TO: ALL OWNERS AND OPERATORS OF CLASSIC WACO YMF-5 AIRCRAFT

SUBJECT: OVERHEATING OF EXHAUST PIPES WITHIN THE HEAT EXCHANGERS

The outlet hole in the bottom of the airbox is small for the amount of air trying to flow through the muffs. A simple modification to enlarge the outlet hole, as shown on Classic print 51041 (Carb. Airbox Mod.), will help relieve this restriction. We recommend that this modification be made to all classic WACOS at your convenience as it should result in a longer service life for your heat exchangers.

Enclosure - Classic Print 51041

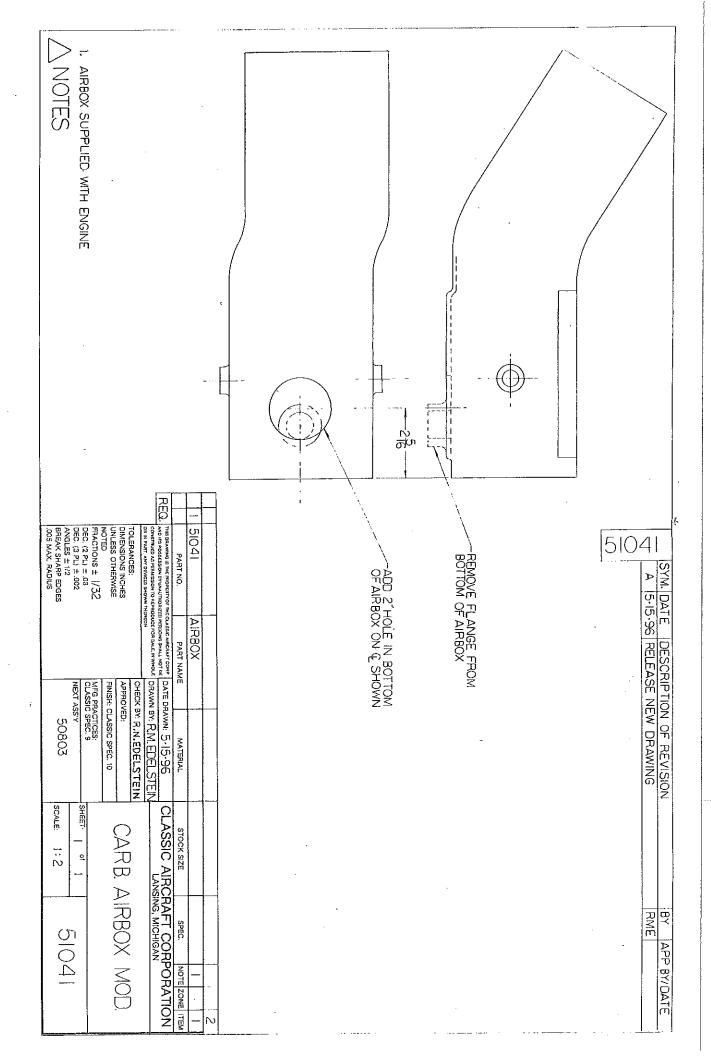
To accomplish this modification, saw off the flange flush with the bottom of the airbox. Then locate the center point of the 2" hole, as shown on Classic print 51041, and drill a pilot hole to match the hole saw to be used. Using a 2" hole saw with a short pilot, (so as not to damage the internal parts of the airbox), saw a hole through the bottom of the airbox. Clean all chips from the airbox and repaint the raw edges of the airbox to prevent corrosion.

KIT #50905M

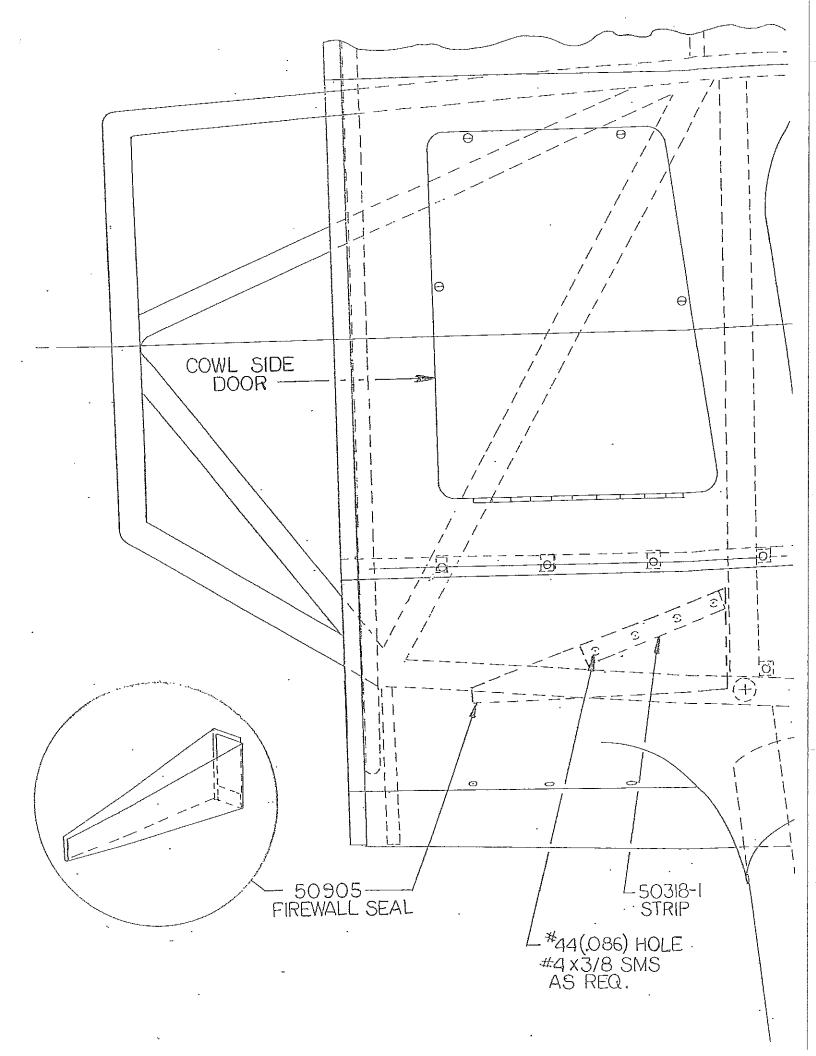
The purpose of this firewall seal is to stop the flow of warm air from the area forward of the firewall back through the landing gear fairing to the cockpit area. The opening to be sealed is located at the forward end of the landing gear fairing and can be seen by opening the cowl side door and looking down and back through the door opening. Notice that the opening is widest at the back and tapers to a point at the front.

Fold the baffle fabric seal to form a triangular shaped open top box and slide into place with the heel of the box against the rear firewall and the point forward. Push the point down far enough to completely close the opening into the fairing. When the seal is properly positioned, cement the top edge and rear tabs of the seal to the firewall only using 3M #8046 adhesive. When the cement has set, secure the inboard upper edge of the seal to the firewall with the 50318-1 strip, attaching it with #4 x 3/8 sheet metal screws as shown on the attached sketch. It may be necessary to trim the length of the strip to fit. Securing the seal only to the firewall allows removing the belly skin and fairings without disturbing the seal installation.
